Tasks Export - Tallinna ringtee (Valingu-Keila) (THK17451)

19 tasks | Generated: 25.5.2026, 09:55:09

Mudelid vales asukohas

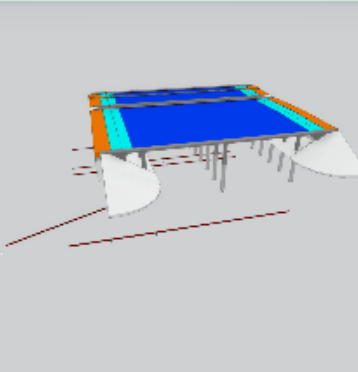
salaoja.ifc ja Valingu-SUL-koond mudelid on vales koordinaadistikus

VMS märgid

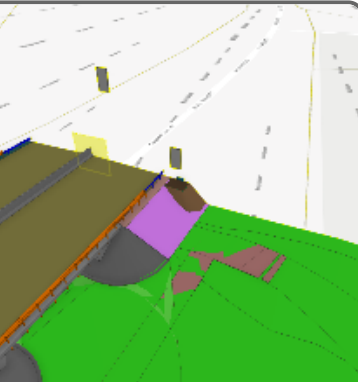
VMS märgid on õhus

Kokku viimata sõidutee ja rajatiste mudelid

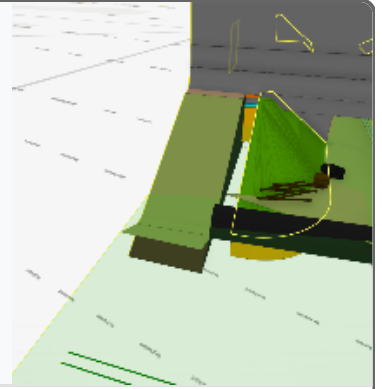
Mudelite vahed

Heki LOD

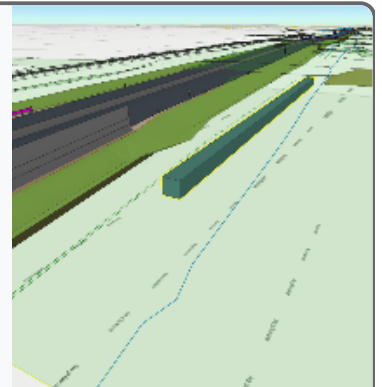
Heki Level of Development ei vasta sobilikule tasemele.

Truubid

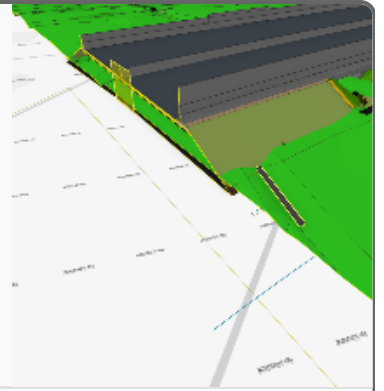
Truupide mudelis arusaamatud. Ei ole aru saada kuidas kraavid ja truubid omavahel kokku jooksevad

Liiklusmärk

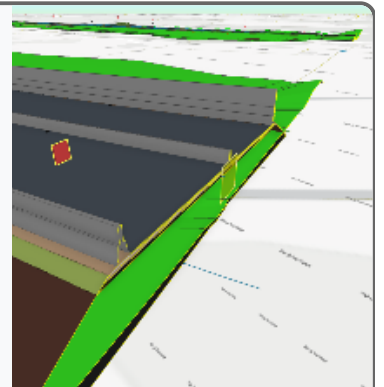
Liiklusmärk ripub õhus

teljed

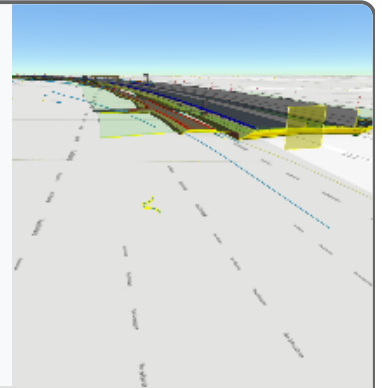
Tee teljed on valel kõrgusel. Osaliselt 0 kõrgusel osaliselt olemasoleva maapinna kõrgusel. Tee teljed viia projekteeritava katte pinnaga ühtima.

Põrkepiire

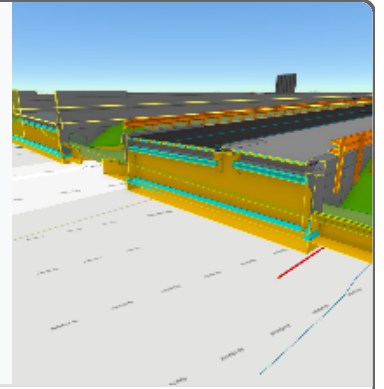
Põrkepiire ei ole mudelis projekteeritud servaprussile (on õhus) ja piirde postid läbistavad servaprussi.

Nõlvade konfliktid

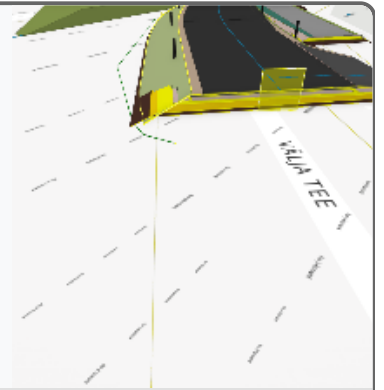
Nõlvad satuvad konstruktsiooni sisse ja on valede pindadega ühendatud (kogu projekti ulatuses läbi vaadata

Nõlvad/Haljastus ja väljakaeve mudelid

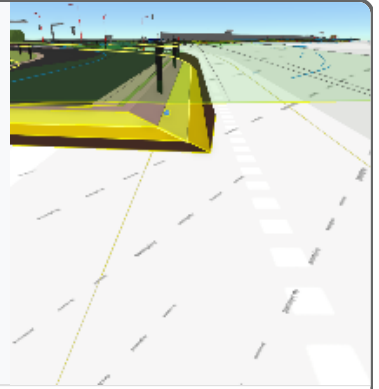
Nõlvad/Haljastus ja väljakaeve mudelid puudu. Nõlvade mudelid puudu kohati kogu projekti ulatuses. Väljakaeve mudelid puudu kohati kogu projekti ulatuses

Kergliiklustee ja sõidutee vaheline konflikt

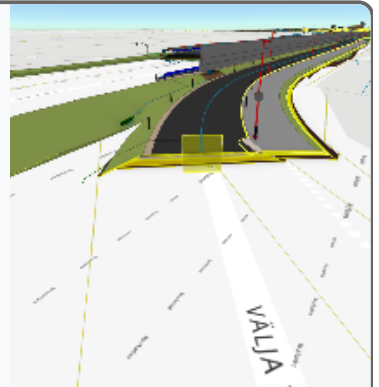
Ebamõistlikult suur konflikt

Pikiprofiilil arusaamtu jõnks

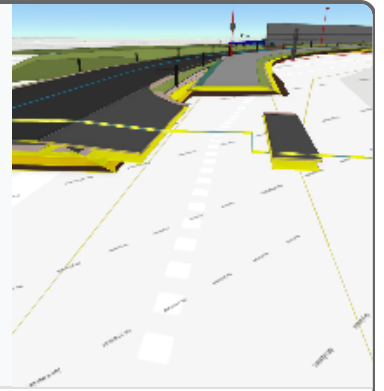
Pikiprofiili arusaamatu s

Arusaamatu muldkeha IFC

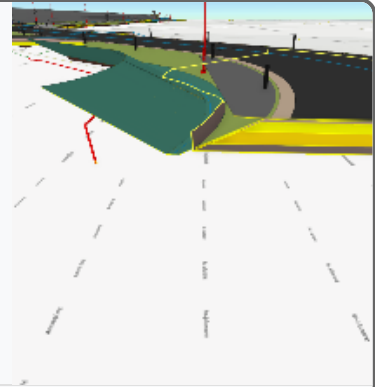
Arusaamatu muldkeha lahendus.

Äärekivi mudelid

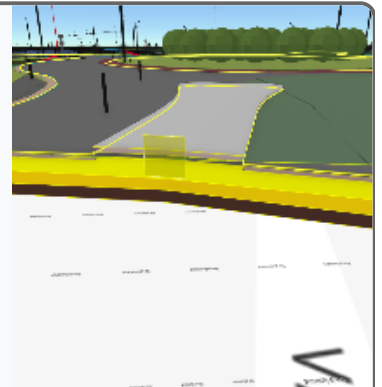
Äärekivi mudelid puudu kogu ringristmiku ulatuses. Nõuetest äärekive ma ei leidnud nii et suure tõenäosusega ei saa veaks pidada.
